CMB Meeting Minutes #177

REFERENCE Project No. M544.1, Contract No. 149 Task 1-8.02

SUBJECT: Configuration Management Board Meeting # 177 – Rev. No. 0

CONTRACT NO.	1254R
DRAWING NO.	SW-4
FILE NO.	03,084
REV. NO.	1

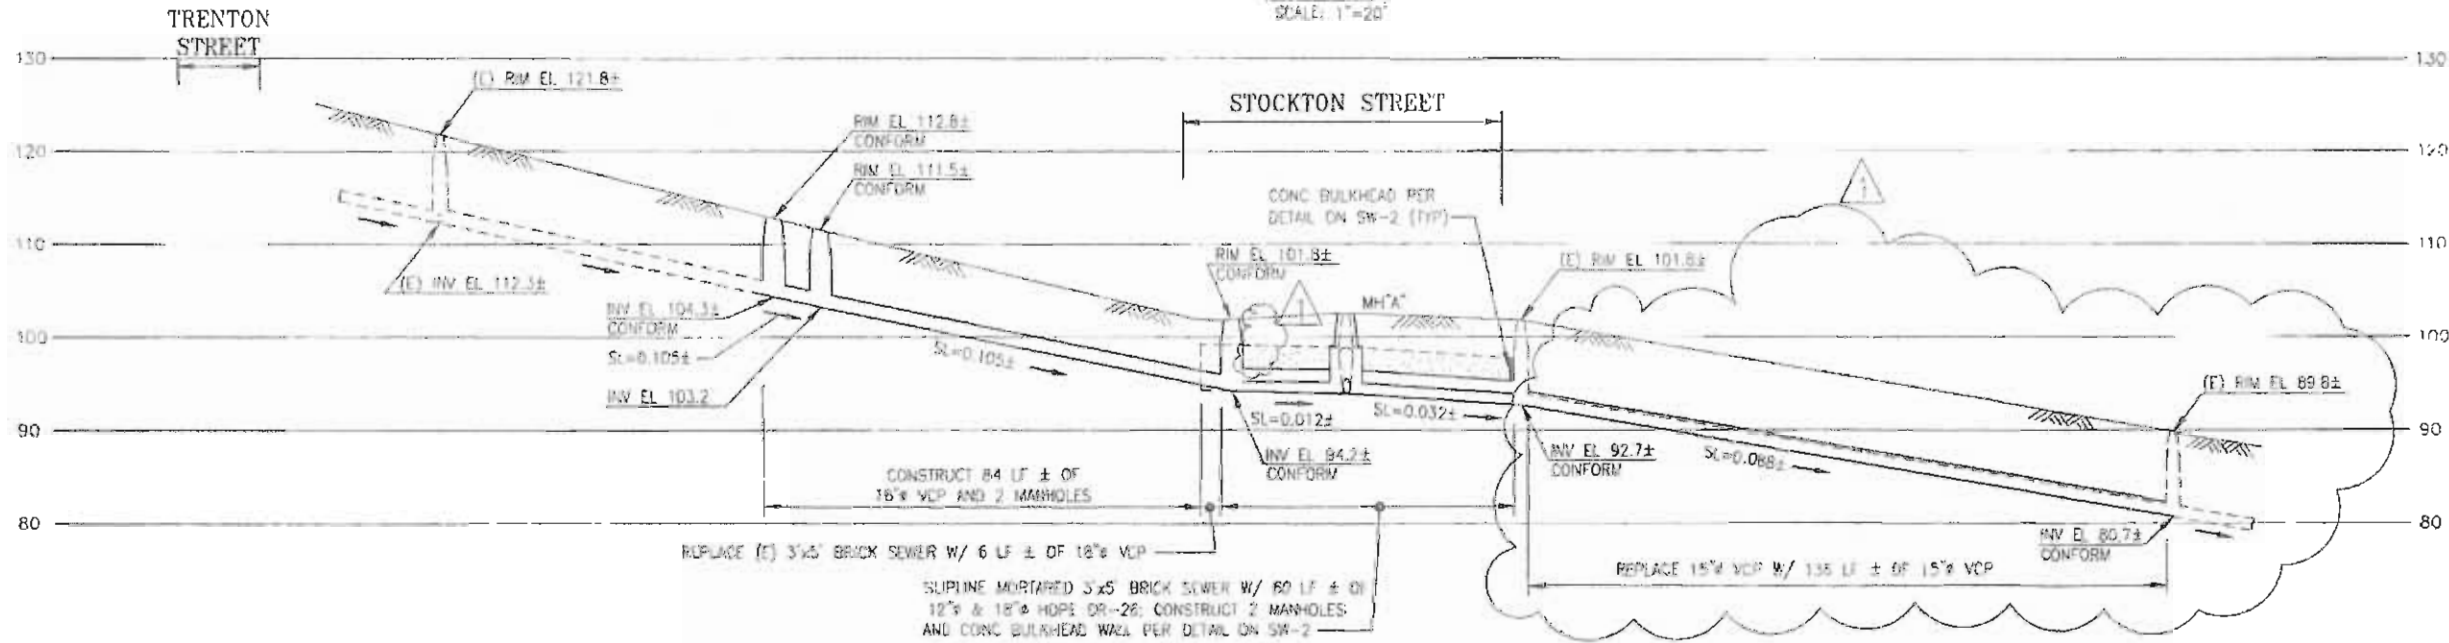
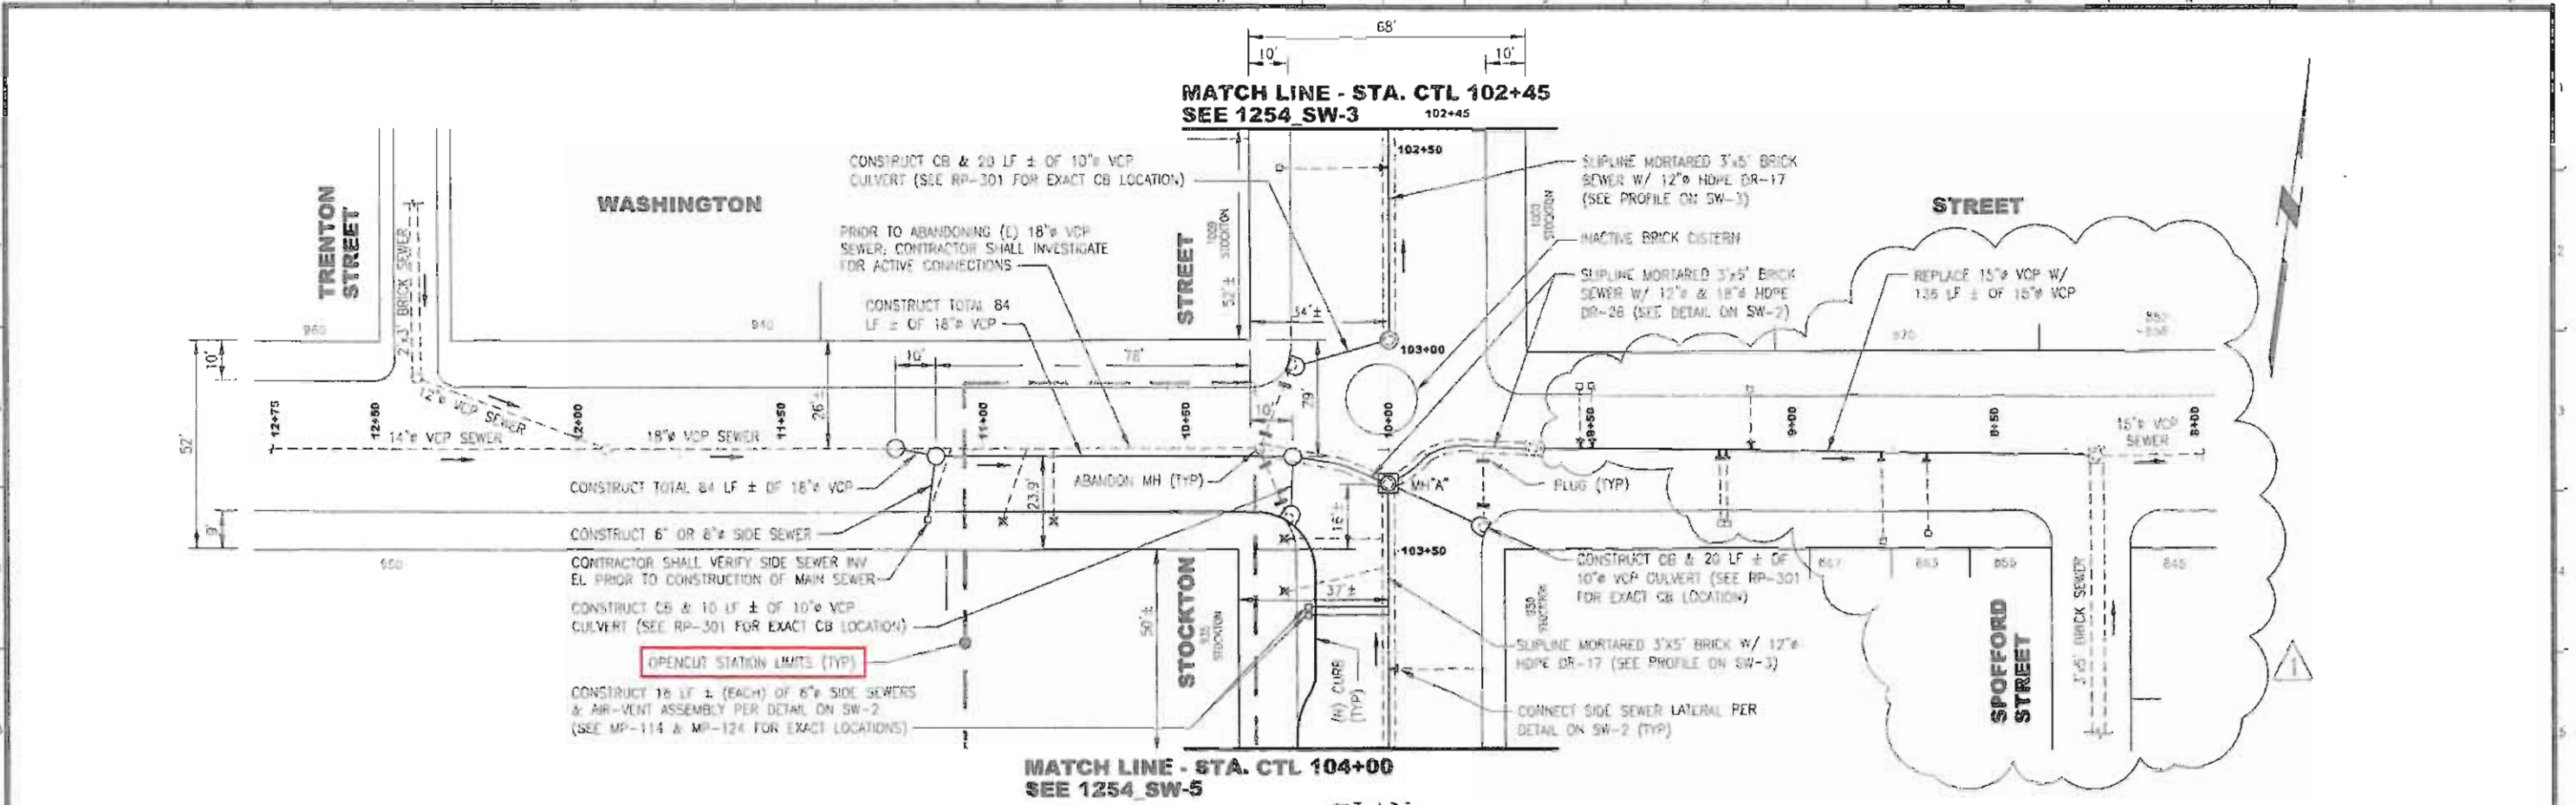
On 6/18/14, Richard Redmond and I had a Level 3 Issue Resolution Ladder meeting to discuss the issue regarding RFI#0005 (CTS-005) Sewer Line Demo at Washington – Interim Routing. SFMTA was informed that Valverde had advised us, based on initial demo of the west slurry wall panel, that the anticipated costs previously estimated and submitted would approximately double. Following that conversation, a handshake agreement to resolve the dispute was made to split the actual costs. In response, Tutor Perini Corporation (TPC) provides herewith a revised lump sum cost proposal for this Change Order Request in the (additive/~~deductive~~) amount of \$43,616.00 (Forty Three Thousand Six Hundred Sixteen and 00/100 Dollars) per the following scope:

Valverde Construction hereby submits its revised estimate to install the temporary sewer line based on actual work performed to date and an updated projection of the work to complete. The revised estimate is:

4th / FOLSOM

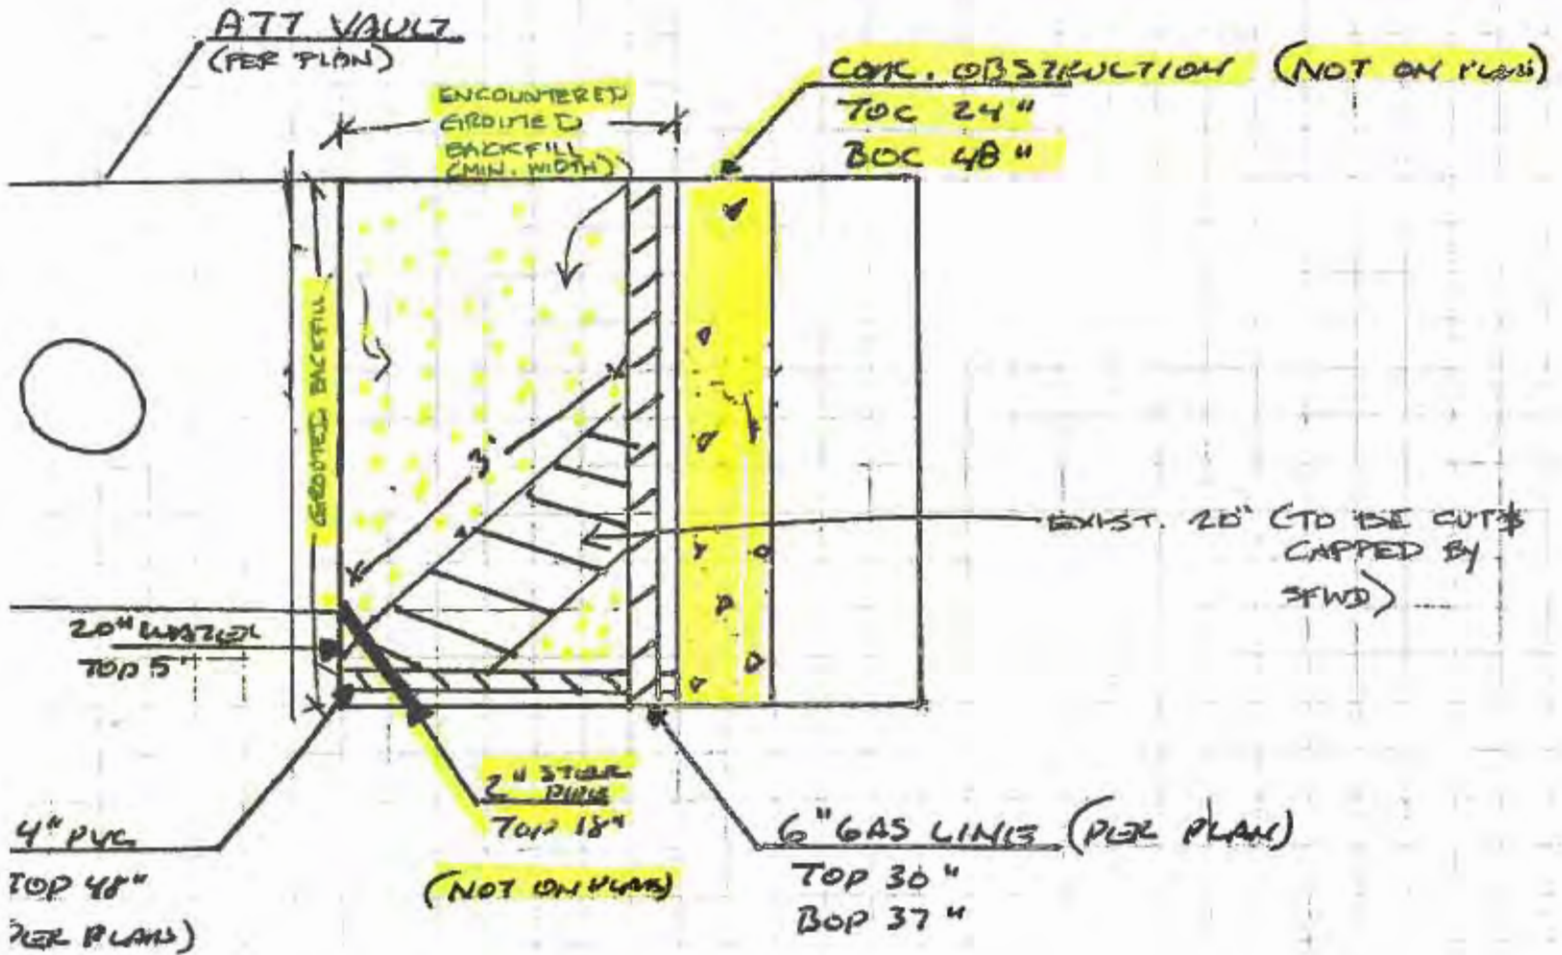
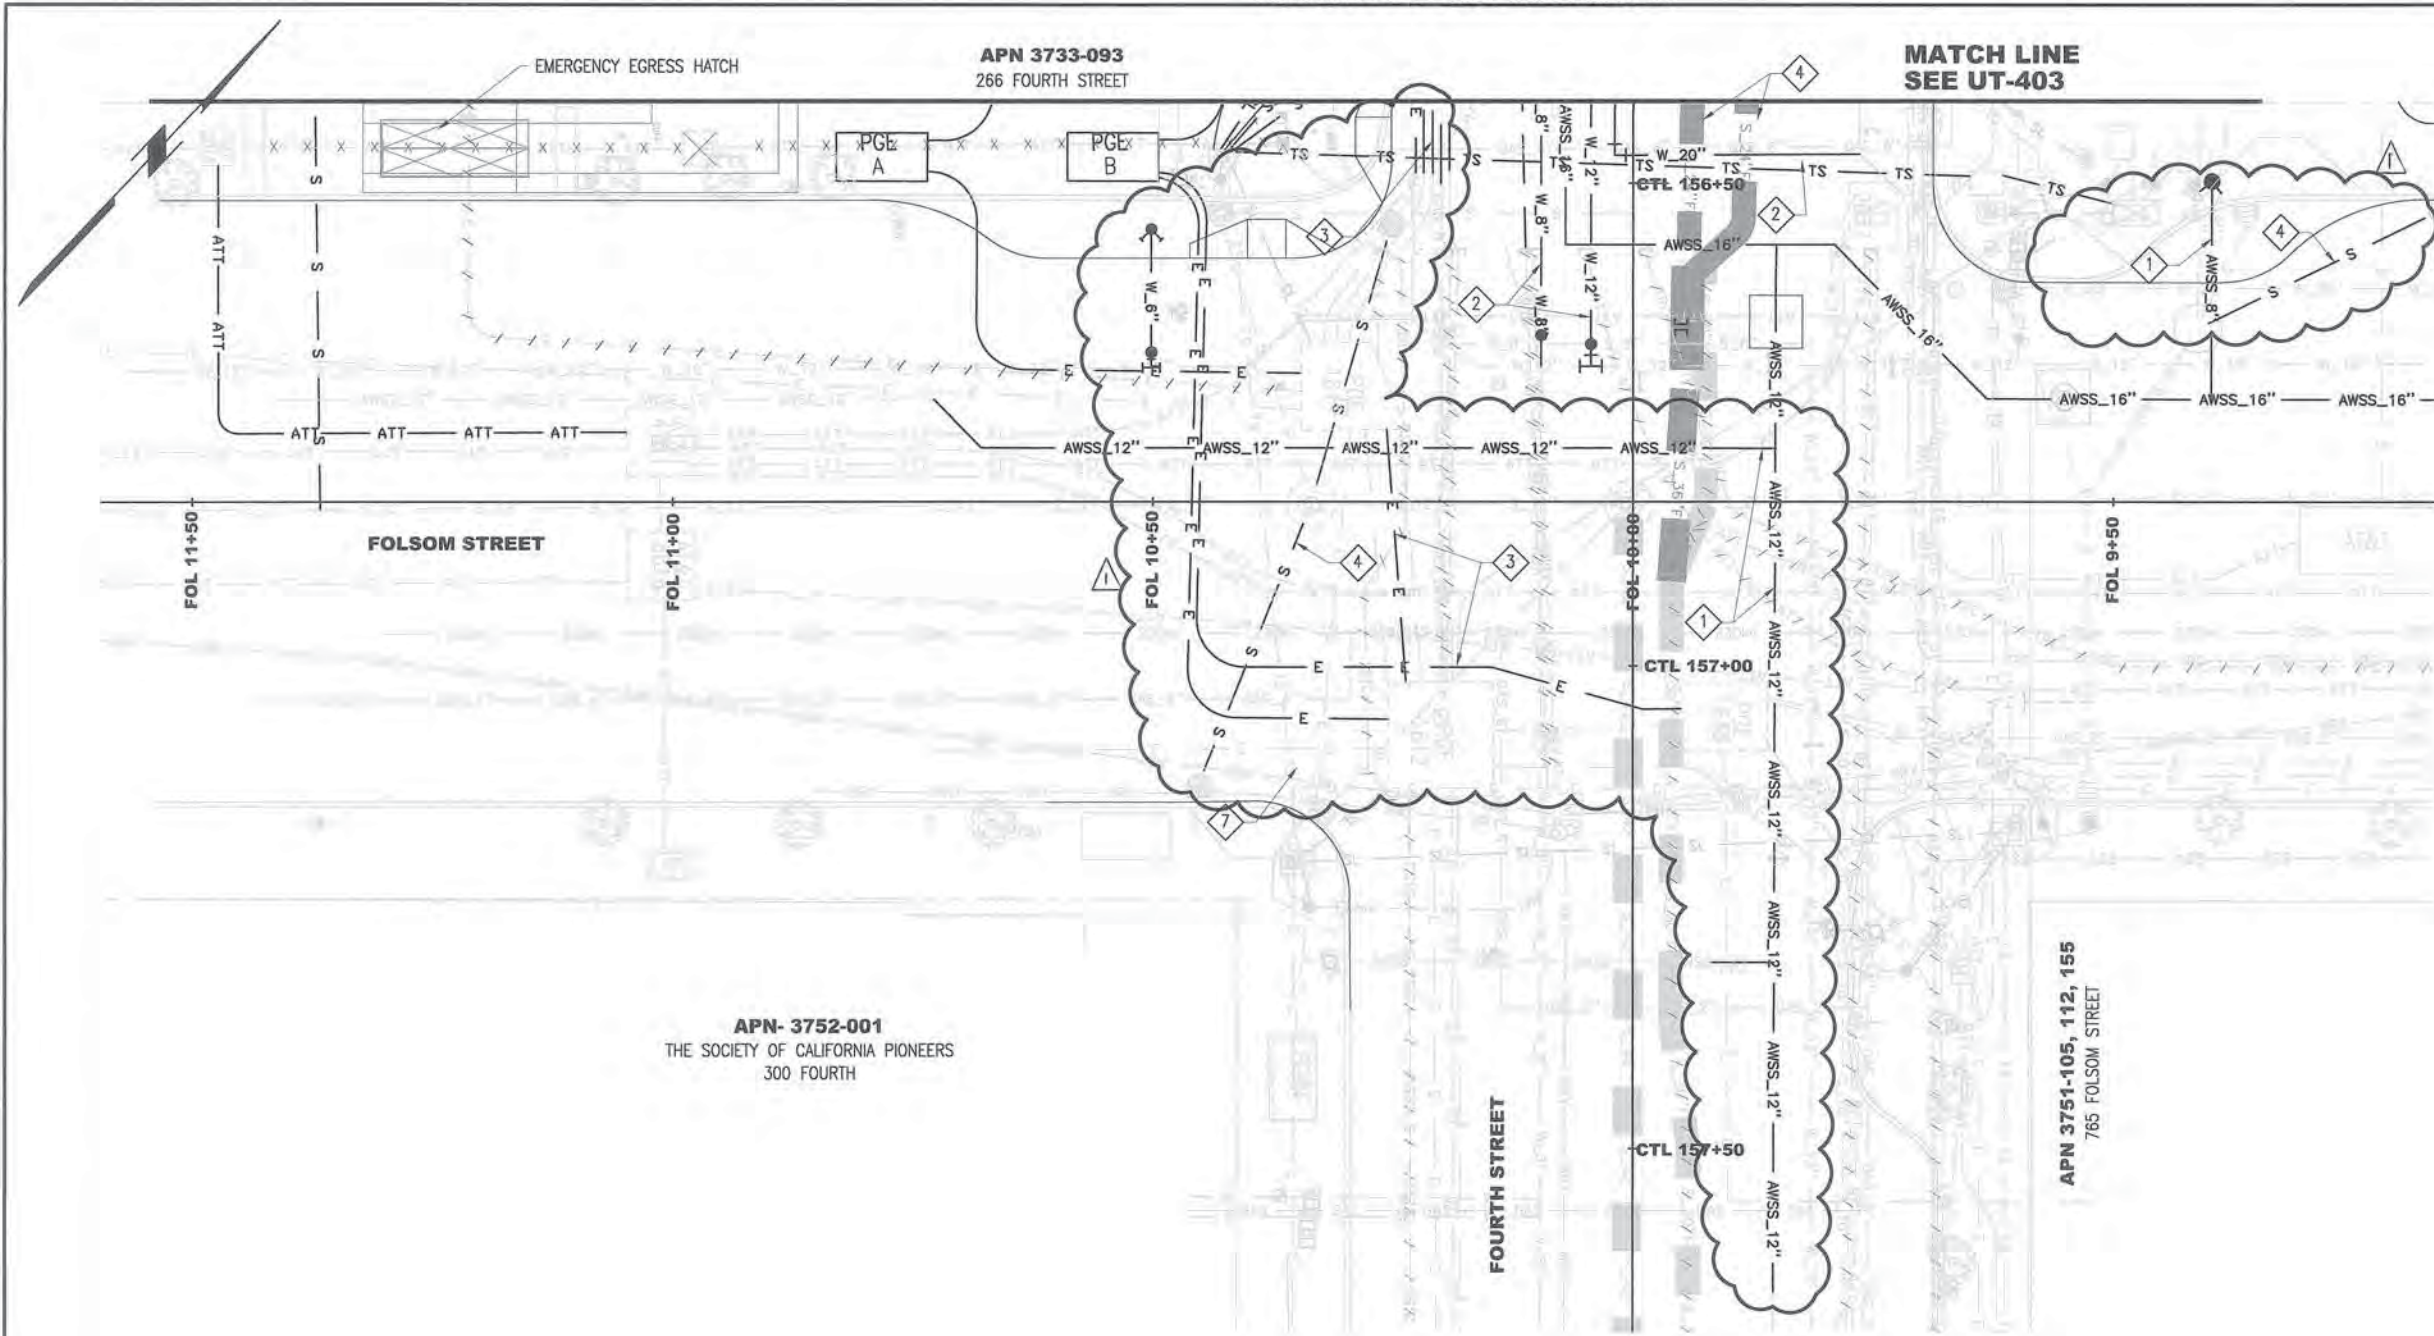
- 4. NATURE OF OBSTRUCTION
Unknown concrete obstruction at planned location of cap of existing 20" water line.
- 5. LOCATION OF OBSTRUCTION Approximately NE corner of intersection at 4th and Folsom Streets.

- 6. METHOD USED TO OVERCOME OBSTRUCTION
Chip out and remove concrete obstruction to allow cut and cap of (E) 20" water line and tie-in of new 20" water.

CONTRACT NO. 1255
SFMTA CONTROL NO. CL-21668
DRAWING NO. UT-413
SHEET NO. 140
REVISION 1

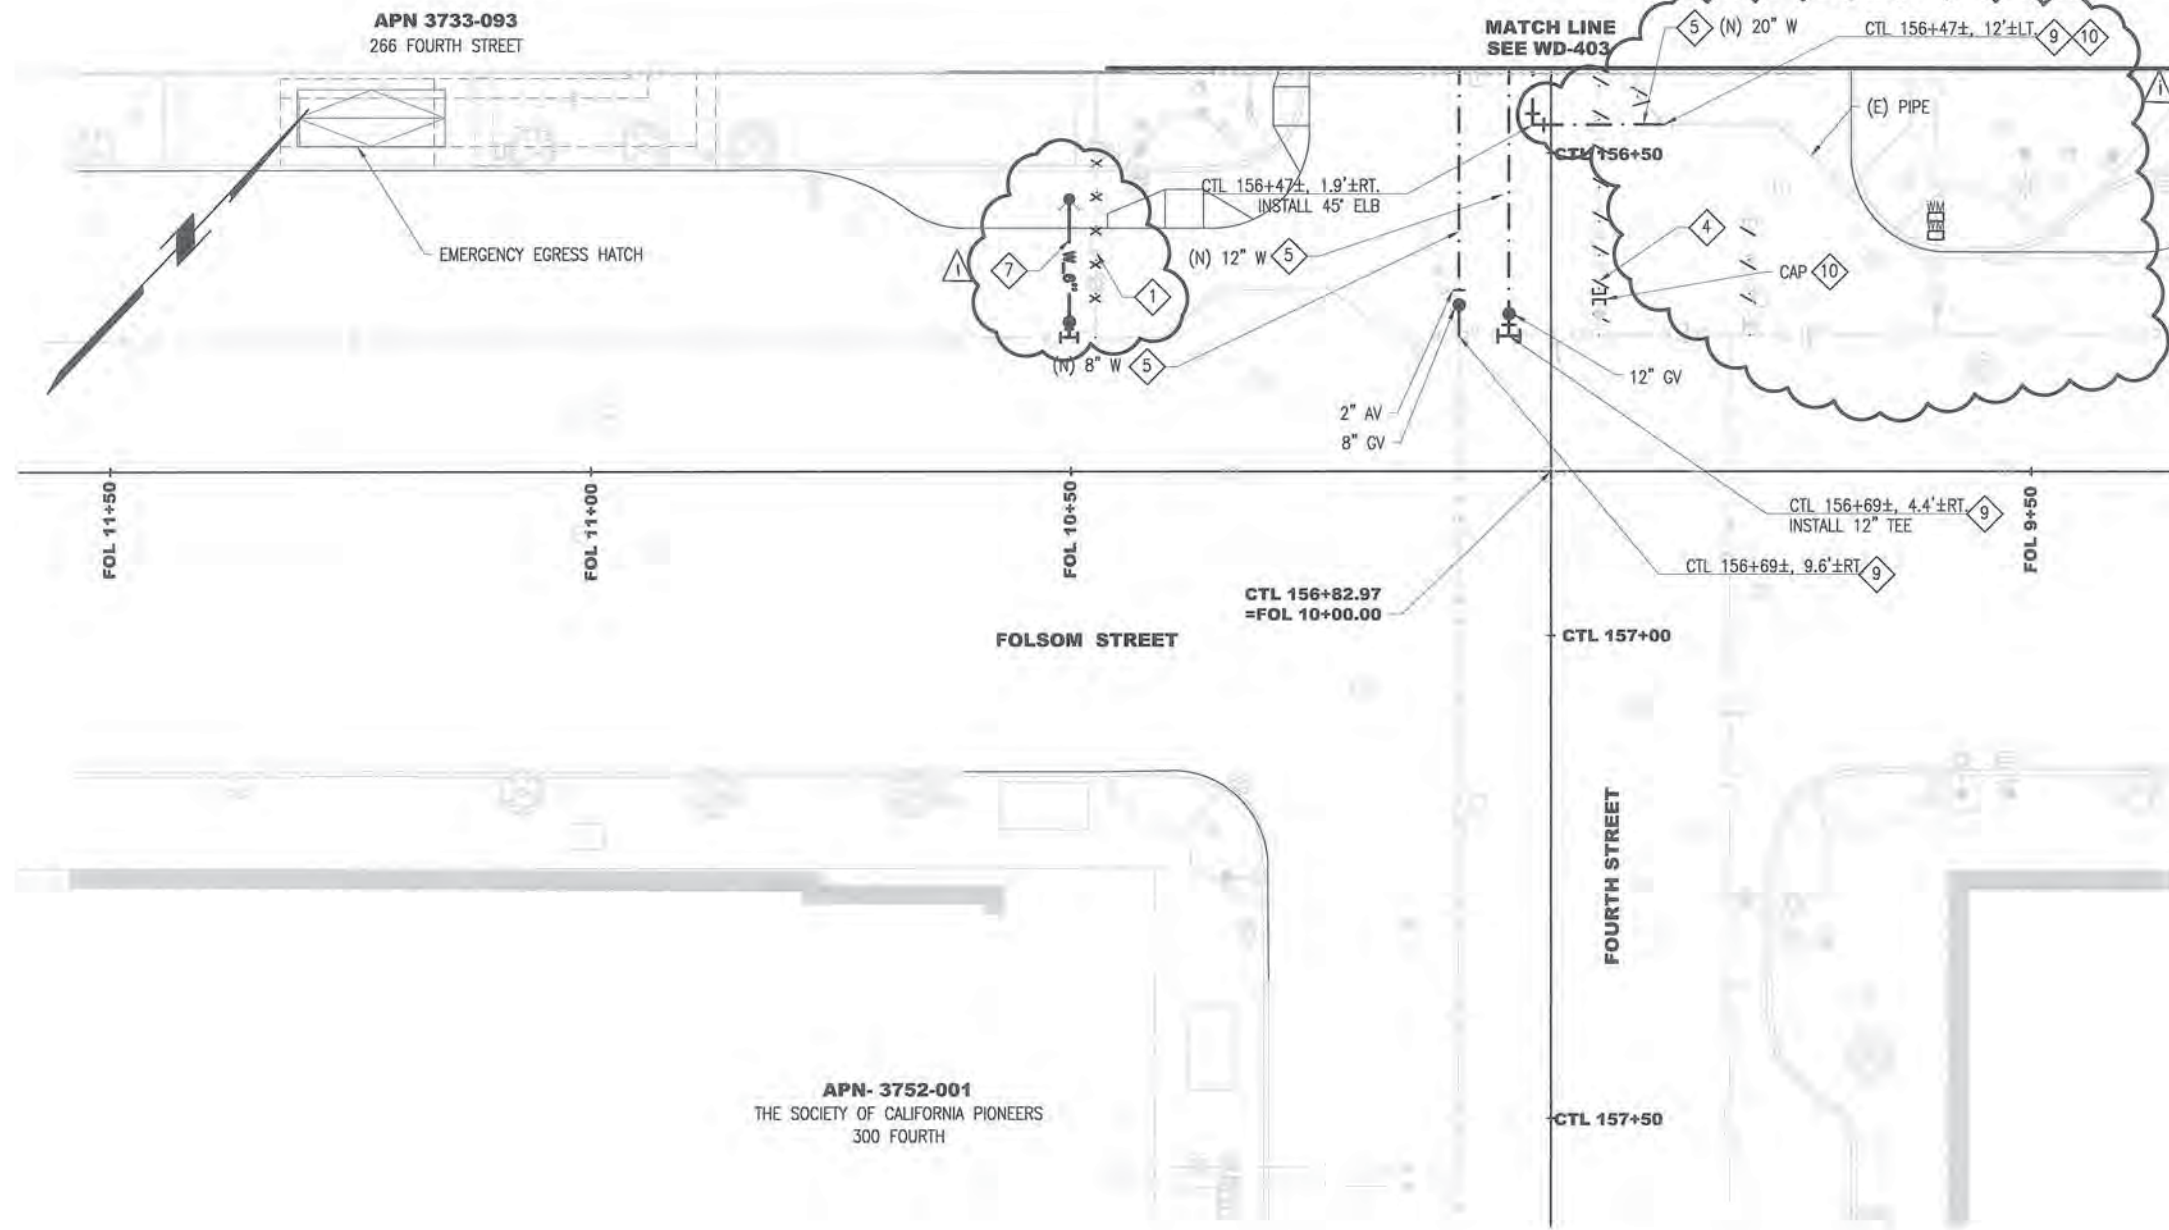
Pursuant to General Provisions 3.04, please see attached correspondence from Valverde Construction dated July 01, 2014 providing Notice of Differing Site Conditions due to an underground concrete obstruction conflicting with the 20" water line cap shown on Sheet UT-413 and WD-413.

Baseline conditions: The WD-413 and UT-413 plans do not show the concrete encasement conflict.

Recommendations: Direct contractor to breakout, remove, and haul away concrete or direct contractor to excavate a new location for the water department to cap the existing water line.
